CAMERA MODULE REPLACEMENT AND ORIENTATION

Bulletin Type:	Recall	Publication Date:	June 2024
Bulletin #(s):	24V-309 USA 2024-256 Canada	Make(s):	Entegra Coach
Job Code(s):	9903607	Model(s):	Aspire
Flat Rate(s):	9903607 .30 HR Installation of Module and Brackets	Model Year(s):	2023-2025

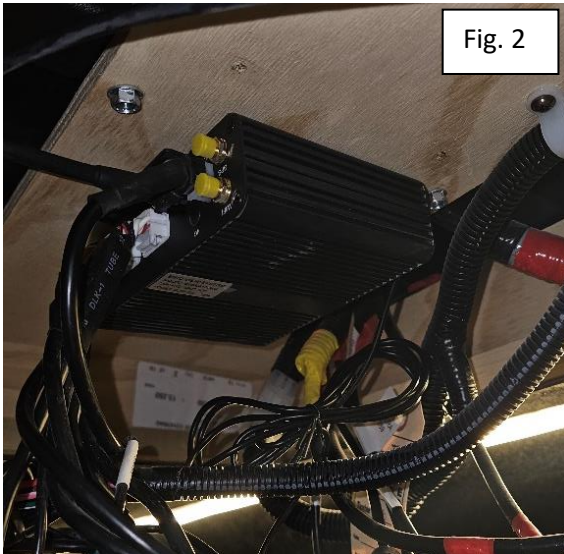
1. Camera module shown behind the access panel in figure 1 on the driver's side door three in the black box mounted to compartment ceiling.

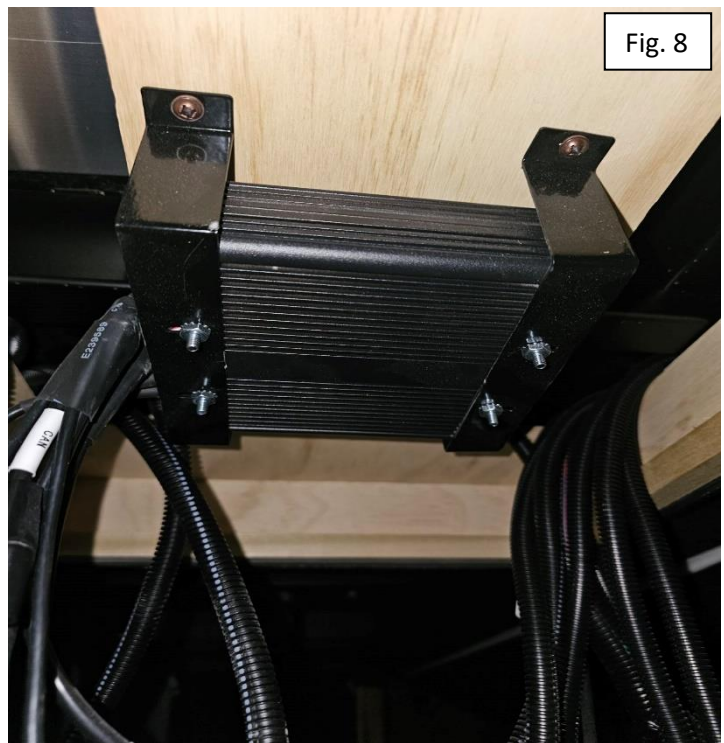
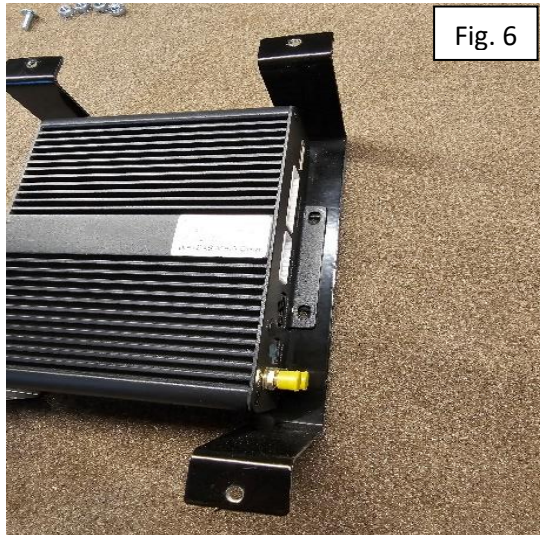
- Figures 2 and 3 show the camera module mounted upside down and flush to the compartment ceiling.

- The correction is to replace the module. Use the new brackets for correct orientation. (Figures 4 and figure 5)

2. Attach new brackets to the original brackets using the 4 screws and nuts provided. (Figures 6 and 7)
3. Install new bracket camera module back to compartment ceiling and connect harnesses. (Figure 8)
4. Test operation of all cameras.
